FINAL SUPPLEMENT  
 ENVIRONMENTAL IMPACT STATEMENT  
 FLOOD CONTROL,  
 ROSEAU RIVER,  
 ROSEAU AND KITSON COUNTIES,  
 MINNESOTA

St. Paul District, Corps of Engineers  
 1135 U.S. Post Office and Custom House  
 St. Paul, Minnesota 55101

September 1981

**LETTERS of COMMENT  
and  
CORPS RESPONSES**

Badger, Minnesota  
Aug 26 - 1980

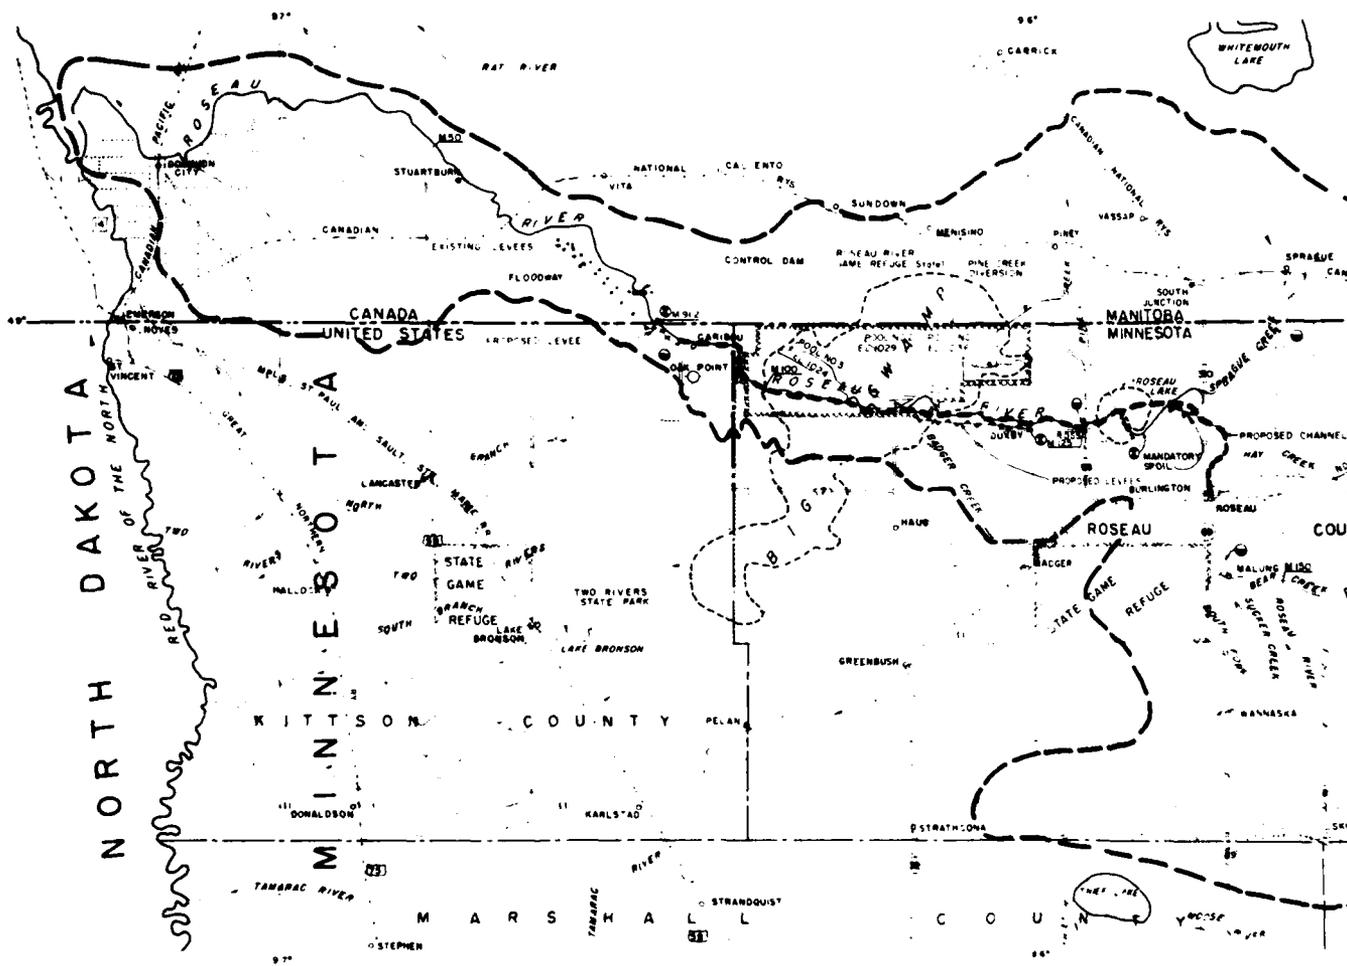
In regard to the Roseau River Project enlarging  
the existing & limited straightening of the Roseau river  
channel and construction of levees through certain  
areas on southside of the channel.

Corps Responses to Comments from Melford E. Nelson  
1. Please refer to the response to the letter from Mr. Vernon Erickson.
